Addendum No. 001

Subject: 2020 Classroom Modernizations

Location: John Welsh School

This Addendum, dated February 28, 2020, shall modify and become part of the Contract Documents for the work of this project. Any items not mentioned herein, or affected by, shall be performed strictly in accordance with the original documents.

PROJECT TITLE CLASSROOM

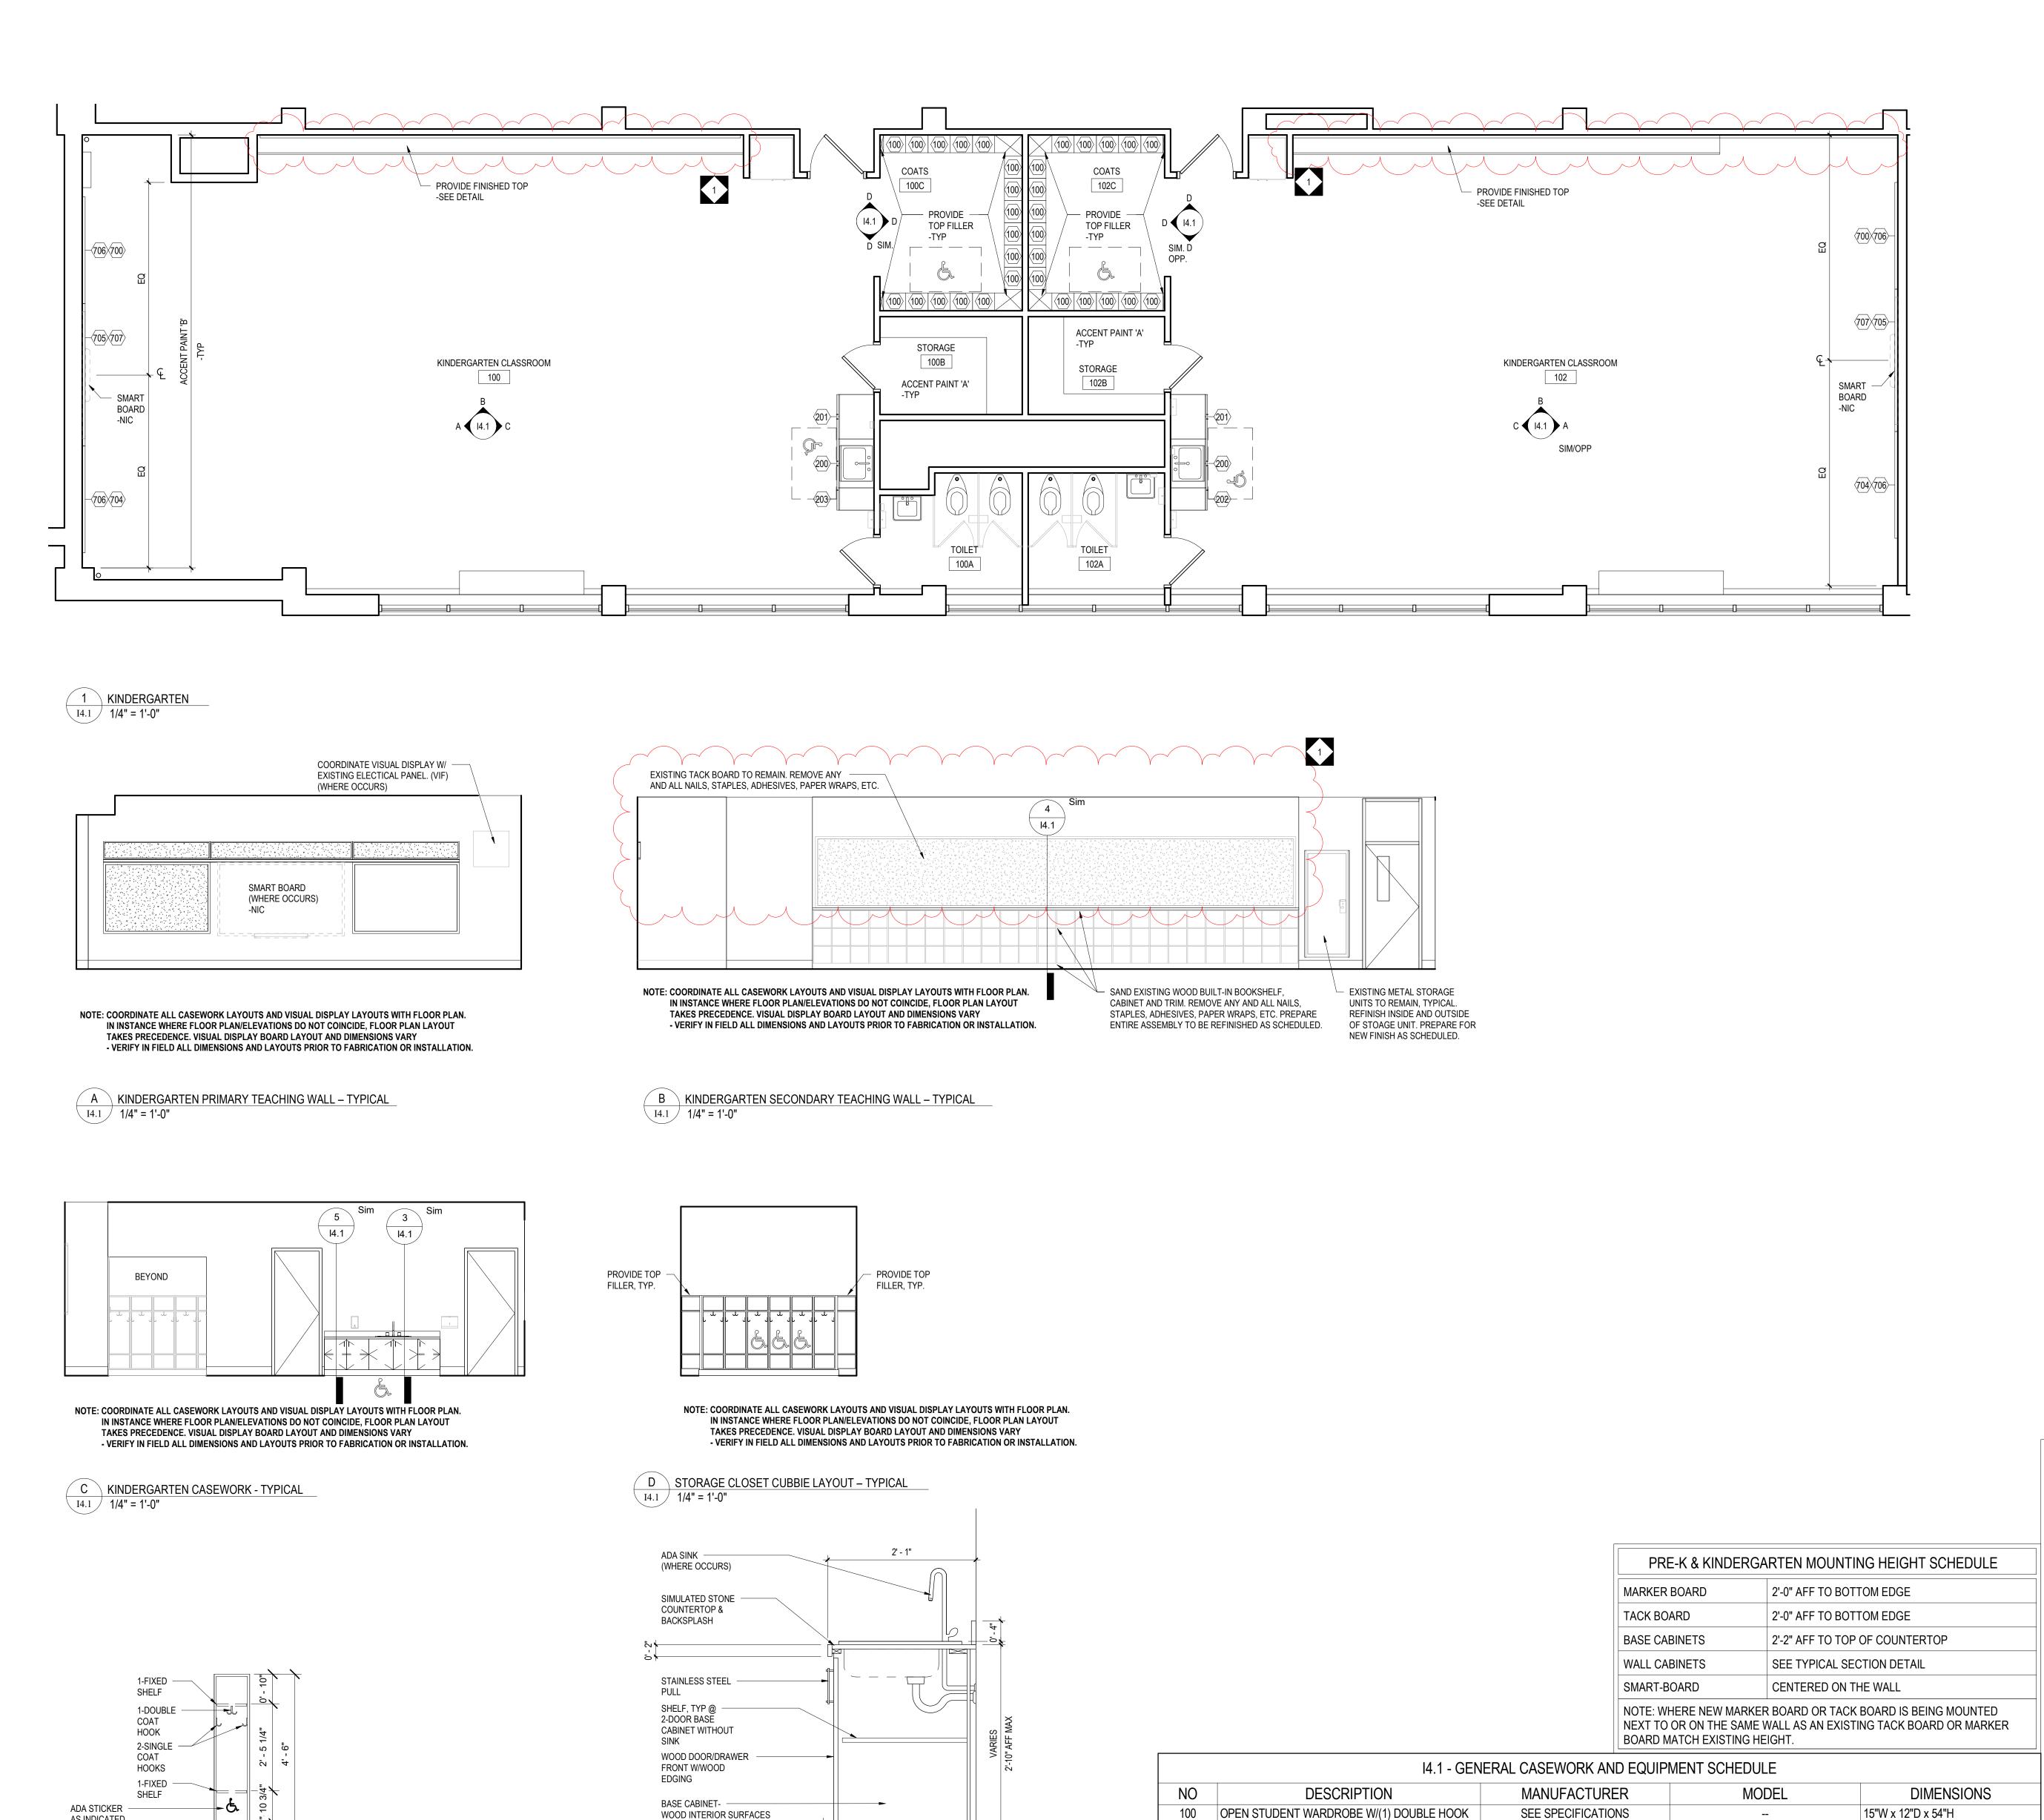
- 1. REVISED Door Schedule to show doors 100, 102, 202, 205, 211, 212, 300 and 303 as new, as indicated on drawings.
- 2. REVISE Room Finish Schedule column "COLOR SCHEME" at ROOMS 211, 212 to correspond to Color Scheme "C".

- 3. REVISE Room Finish Schedule column "COLOR SCHEME" at ROOMS 300, 303 to correspond to Color Scheme "D".
- 4. REVISE Color Scheme Schedule Color Scheme A to read as: "COLOR SCHEME A KINDERGARTEN".

1 ELECTRICAL THIRD FLOOR LIGHTING PLAN
E1.3 1/8" = 1'-0"

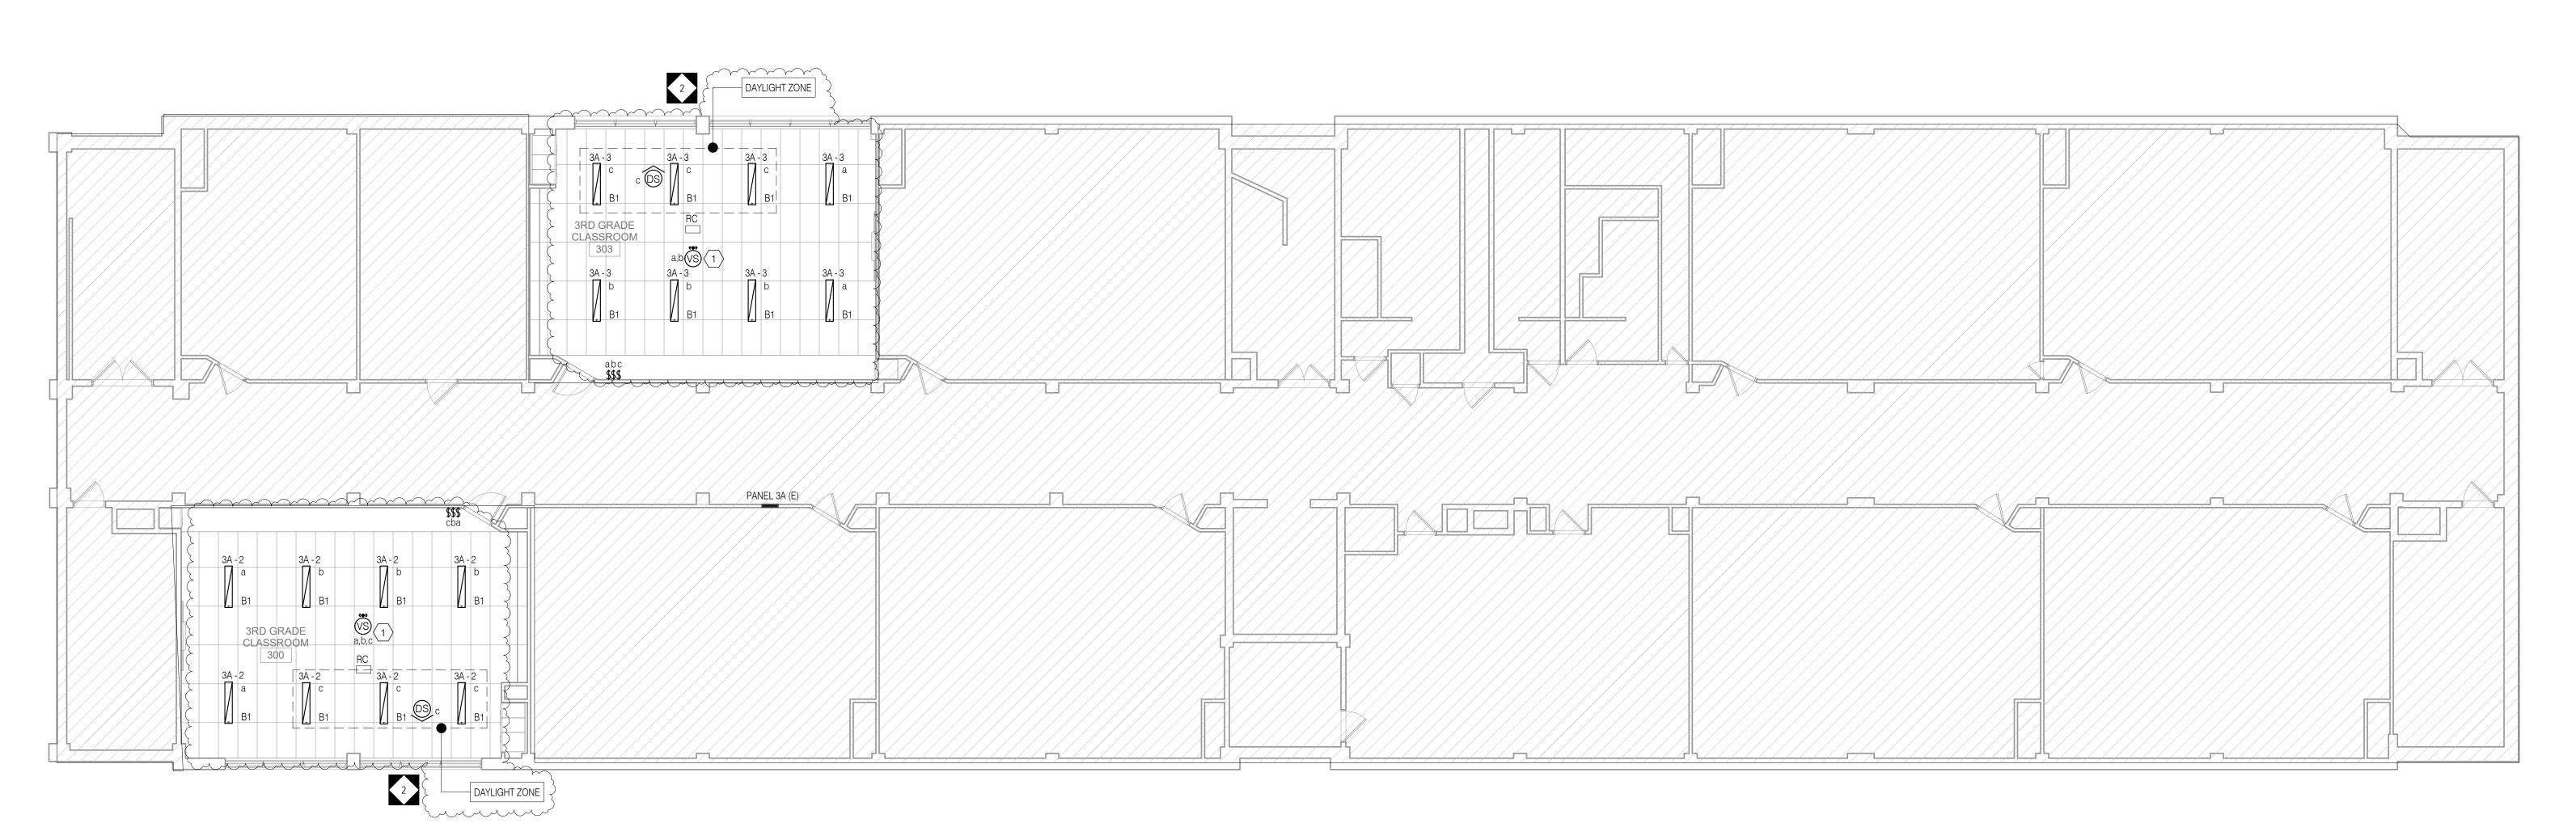
- 1. REVISE lighting layout as indicated on the drawings.
- 2. ADD daylight zone and associated sensor and control switch to Classrooms. Per load of new pendant mounted fixtures, daylight zone is now required by code.
- 3. REMOVE note to provide new switches in existing back boxes per drawings, as 3 switches will not fit in the existing back box

1 ELECTRICAL FIRST FLOOR POWER PLAN
E2.1 1/8" = 1'-0"

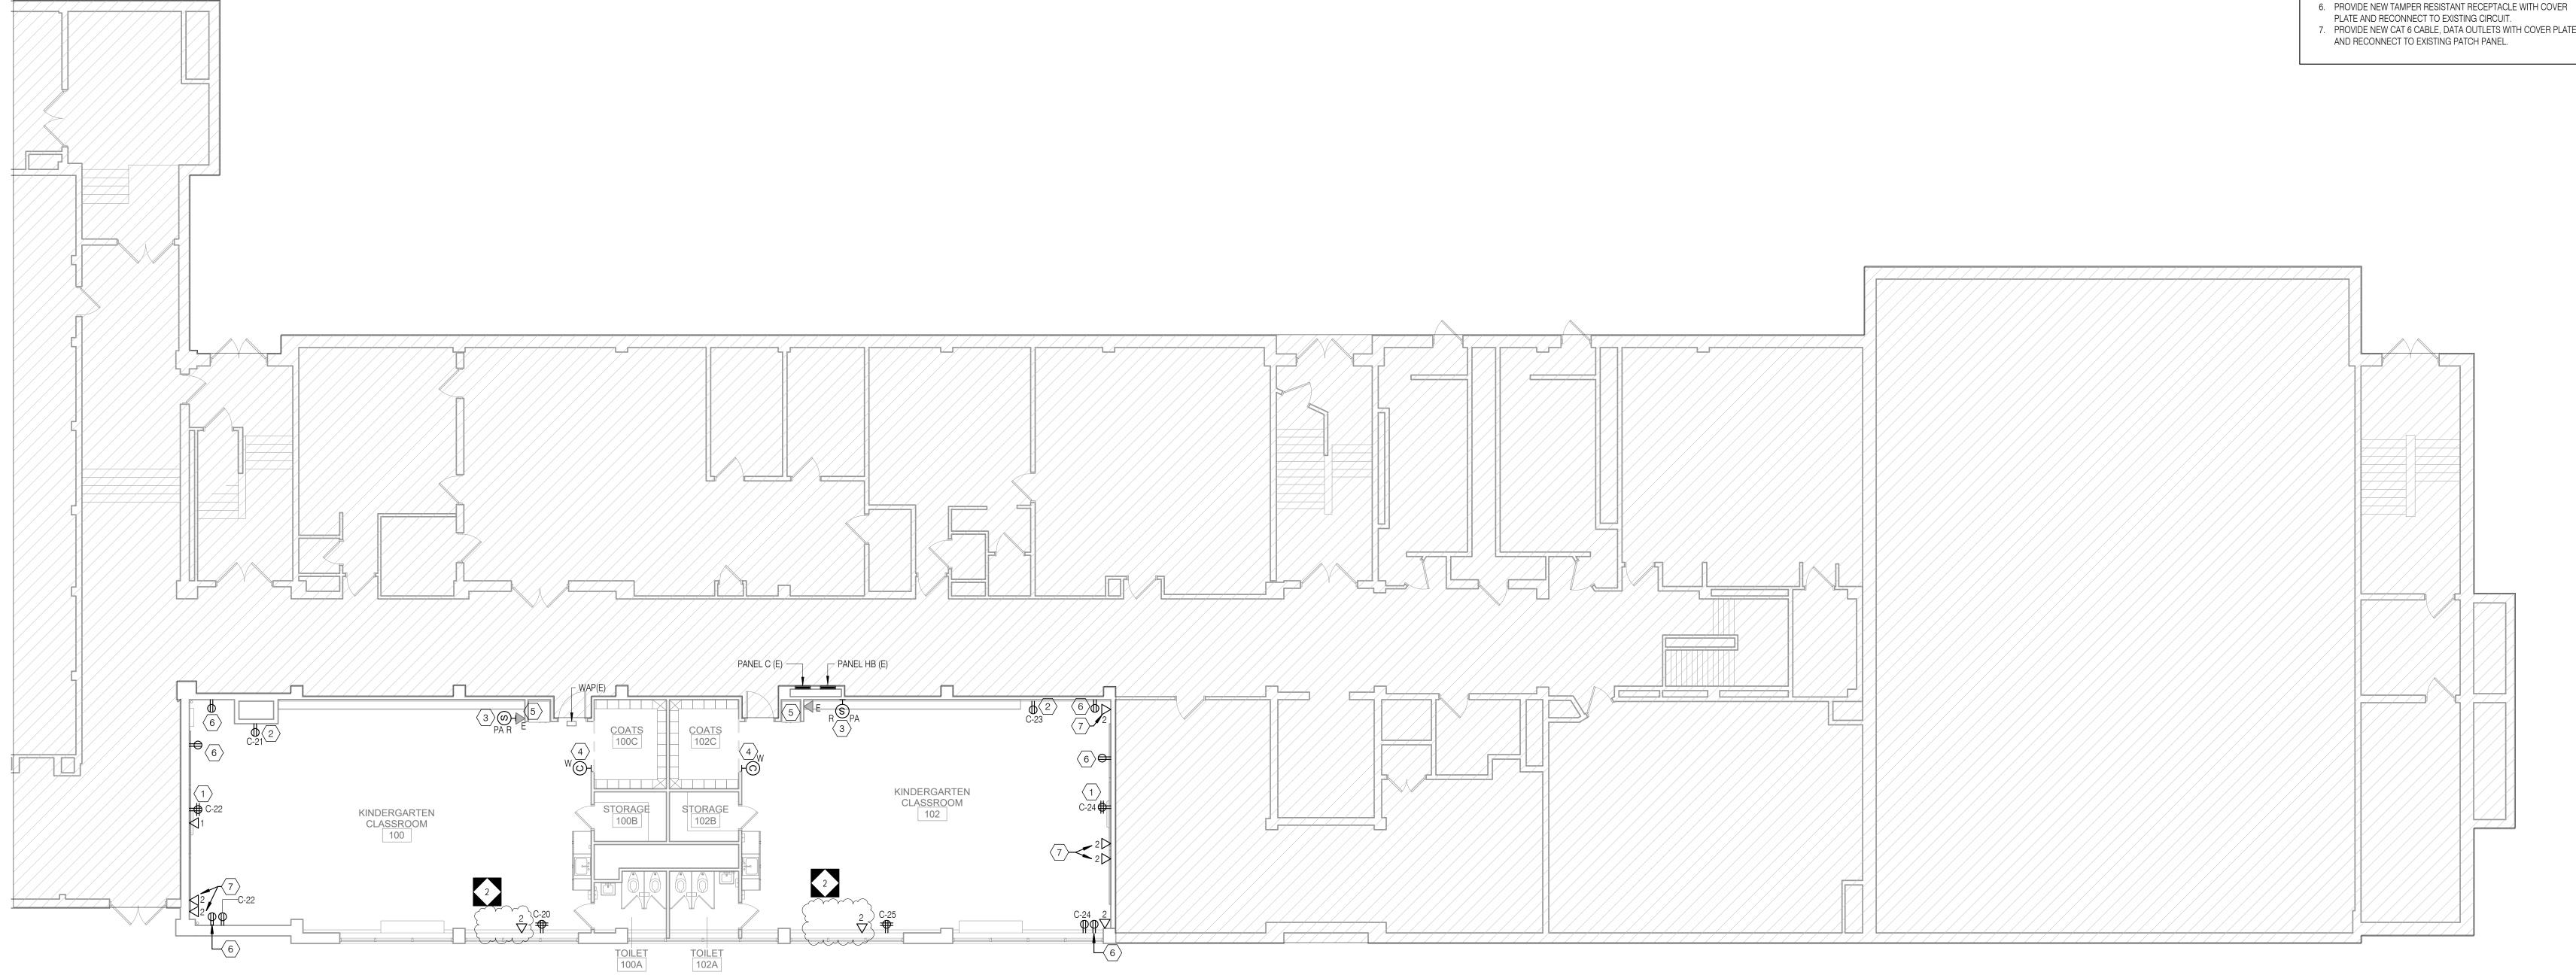
- ADD general sheet note #6 to read "ELECTRICAL CONTRACTOR TO RUN ALL NEW SURFACE MOUNTED CONDUITS AND RACEWAYS IN CORNERS OFF EACH CLASSROOM TO AVOID CONFLICT WITH DISPLAY BOARDS AND OTHER CLASSROOM FURNISHINGS."
- 2. REVISE data outlet locations and scope as indicated on the drawings.

1 ELECTRICAL SECOND FLOOR POWER PLAN E2.2 1/8" = 1'-0"

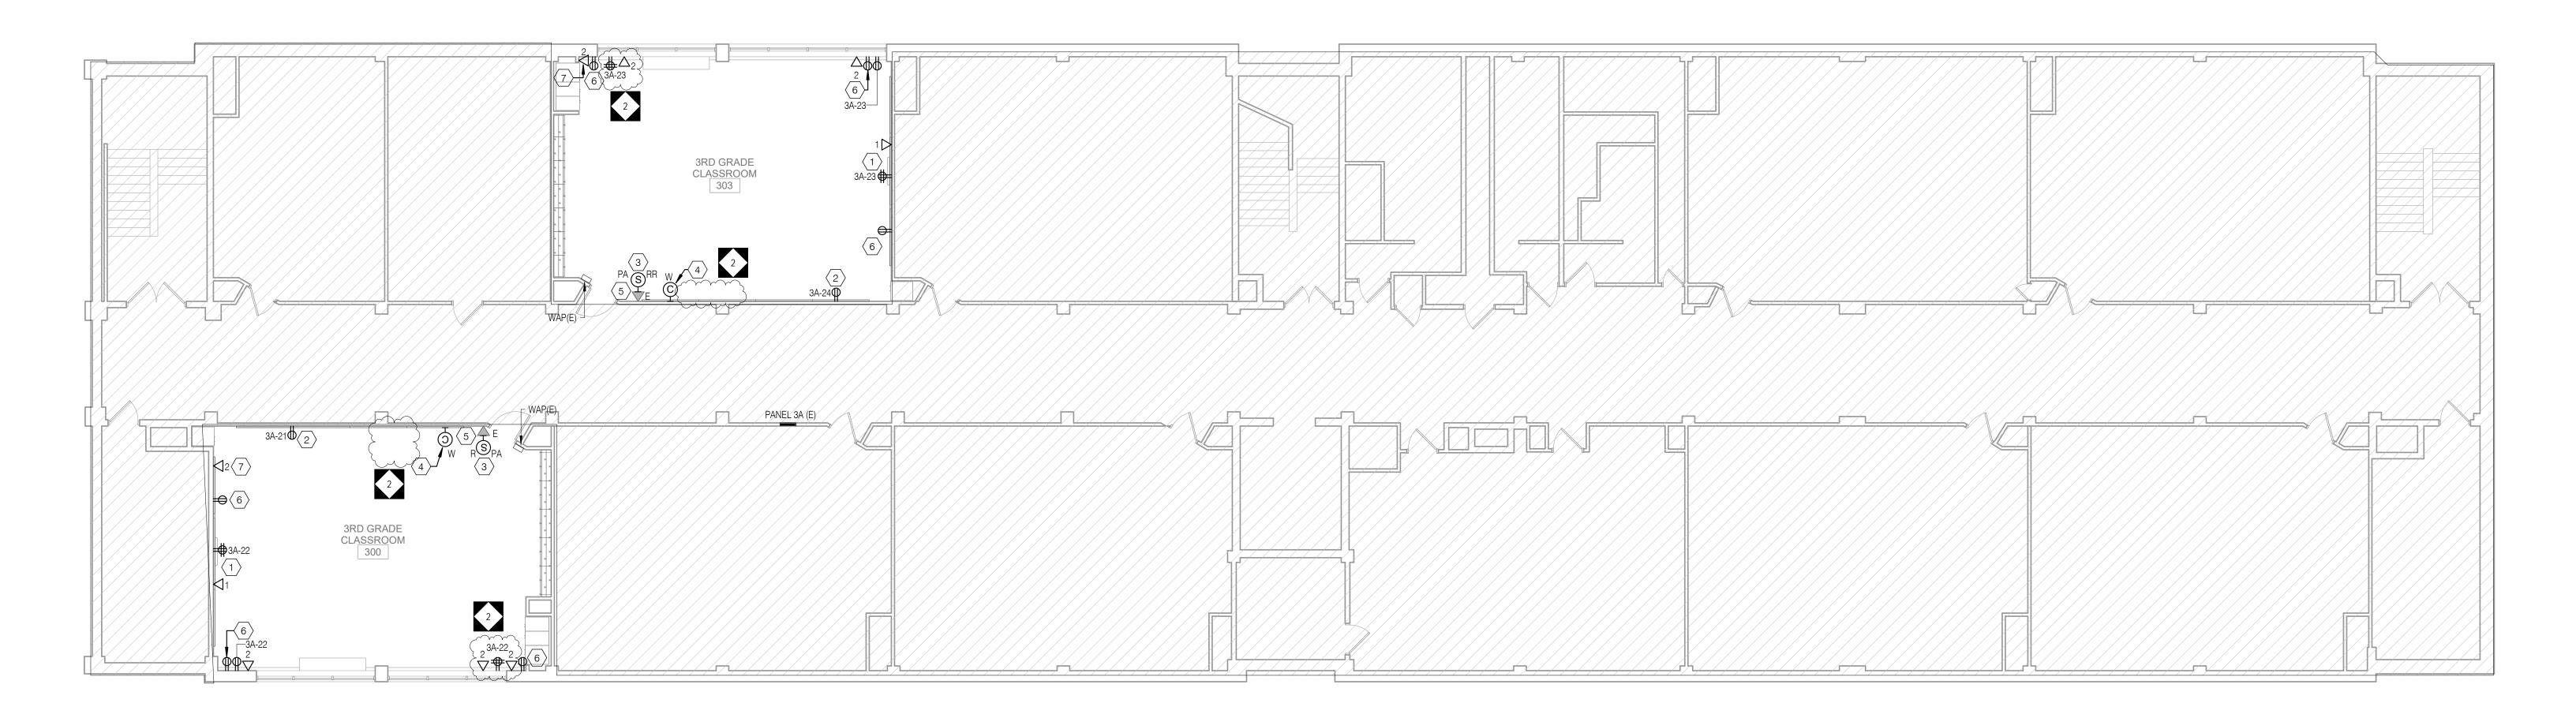
1. ADD general sheet note #6 to read "ELECTRICAL CONTRACTOR TO RUN ALL NEW SURFACE MOUNTED CONDUITS AND RACEWAYS IN CORNERS OFF EACH

- CLASSROOM TO AVOID CONFLICT WITH DISPLAY BOARDS AND OTHER CLASSROOM FURNISHINGS."
- 2. REVISE data outlet locations and scope as indicated on the drawings.
